**London Luton Airport Way Luton
AONB Special Qualities Study 2nd Draft (Deadline 7)
Comments on any further information/ submissions received by Deadline 6**

My Ref.: F: Planning\Development Management\Luton.
Application by London Luton Airport Limited for an Order Granting Development Consent for the London Luton Airport Expansion project. Notification of decision to accept an application for Examination for an Order Granting Development Consent.

**Chilterns AONB Special Qualities Assessment (2nd draft) 7th January 2023
consultation by Arup/Aecom consultants.**

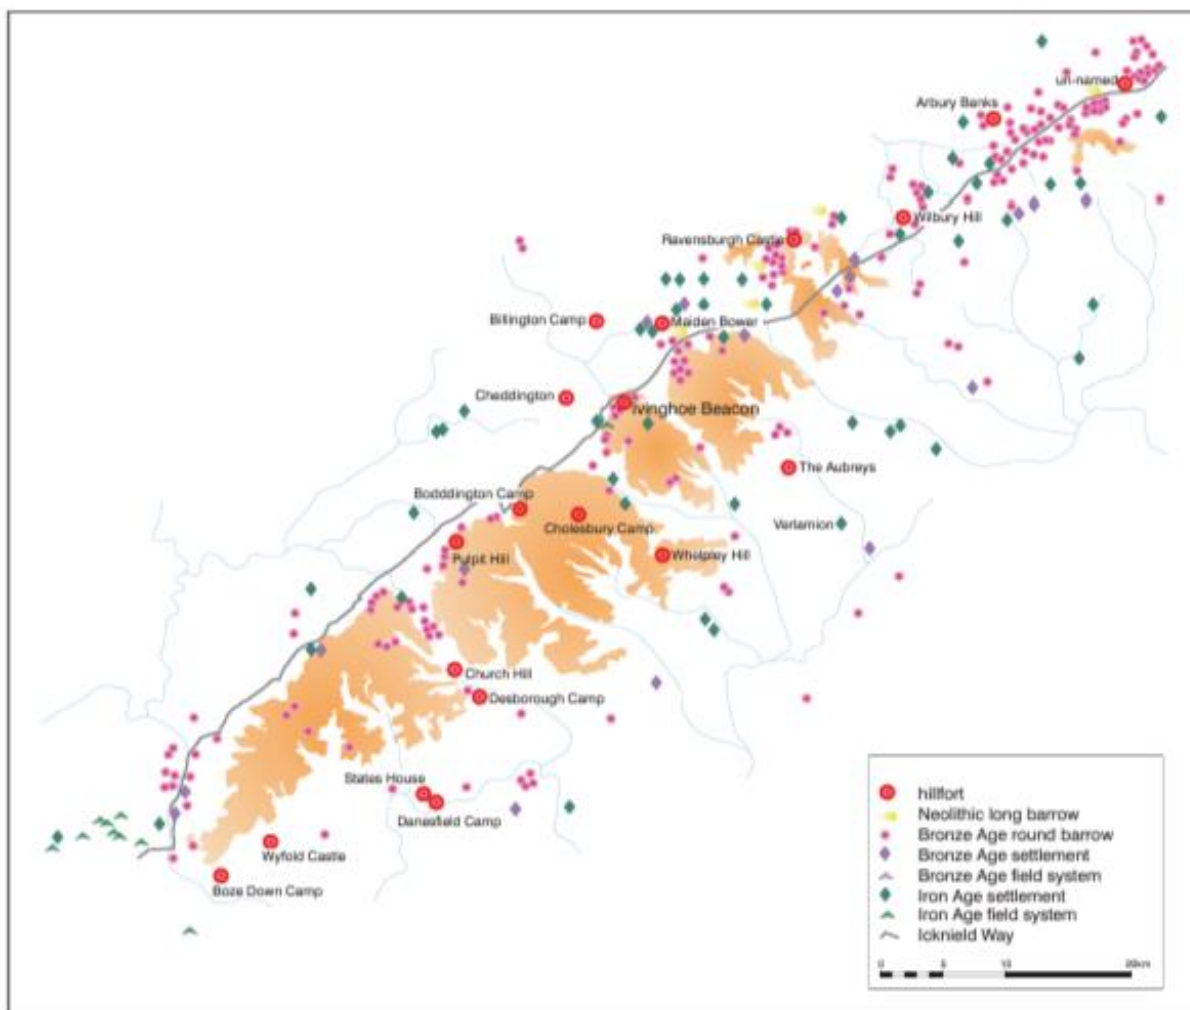
A disagreement remains as to which special qualities linked to relative tranquillity are impacted by the proposed expansion. **The CCB maintains that the setting of an archaeological and dramatic chalk escarpment along the Chilterns Ridge is impacted**, for example, Bronze and Iron Age archaeology at Ivinghoe, Pitstone and Aldbury Nowers. The ExA visited Ivinghoe Beacon during their site visits on Tuesday 23rd May 2023. Aircraft overfly this landscape at or below 7,000ft. The ExA noted that *'the footpath leading to the Beacon is under the footpath'*. (Case Ref: TR020001 The Examining Authority's Note of an Unaccompanied Site Inspection).

The sweeping escarpment of the Chilterns Ridge is rich in archaeology. To illustrate this point, we have pasted (below) Figure 3 from an English Heritage study in 2001, which shows the Bronze Age and Iron Age landscape of the Chilterns Ridge. The CCB is itself heavily engaged in the 'Beacons of the Past' National Lottery Heritage Fund project to record and improve the condition of the many Hillforts that pepper the escarpment, historically taking advantage of its topography and bequeathing what is now a strong place identity. In November 2023, Cholesbury Camp was removed from the Heritage-at-Risk register because of this work.
